Altronic Service Bulletin #527

ISSUED: 01/28/22

Altronic V-NG Upgrade Improvements

Improved hardware on the 570410-x Magnet Holder Gear assembly

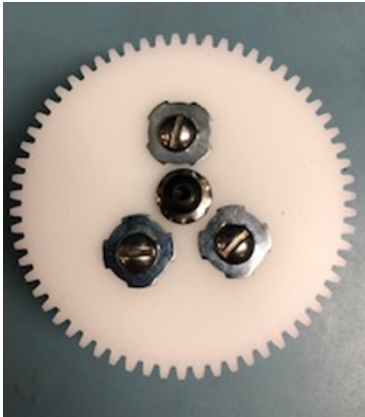
Although most V-NG upgrades have been trouble-free, there have been some high vibration applications that have prompted some ongoing product improvements. The Magnet Holder Gear is an item that is assembled at Altronic, and is a one piece assembly and is only sold assembled as shown. The Gear and the Magnet holder are now attached with longer screws, improved washer size and type, and a thread locking agent is being applied. This is assembled while being held in a fixture to ensure proper centering between these components.

Location of the H-E components:

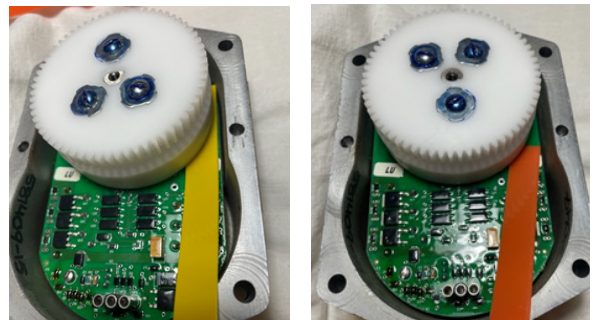
The easiest gap to measure is that between the components located at the 4 and 8 o'clock positions. The GO feeler gauge is yellow and is .020" and should slide between the magnet holder and the H-E component. The NO-GO gauge is orange and is .030" and should not fit between the magnet holder and the H-E component.

Add shims beneath the Magnet Holder Gear as necessary to attain the proper gap. The shims are part number 902579 and are the same part used in the Legacy Altronic V for this same purpose.

Grounding requirements for the PCB and V-NG Unit

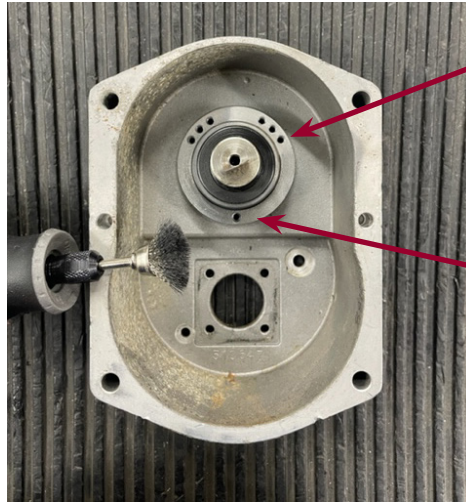
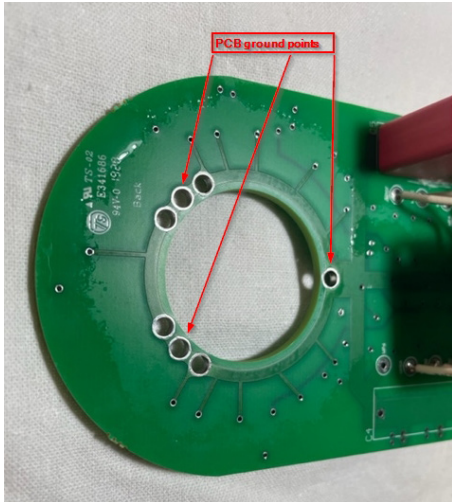
The Altronic V housings will typically have oxidation that must be removed before mounting the PCB. Be sure to wire-wheel the housing where the legacy trigger plates were removed to provide proper grounding of the PCB.

This area is oxidized and needs to be cleaned with the wire wheel.

This area has already been cleaned with the wire wheel and is ready for pcb mounting.
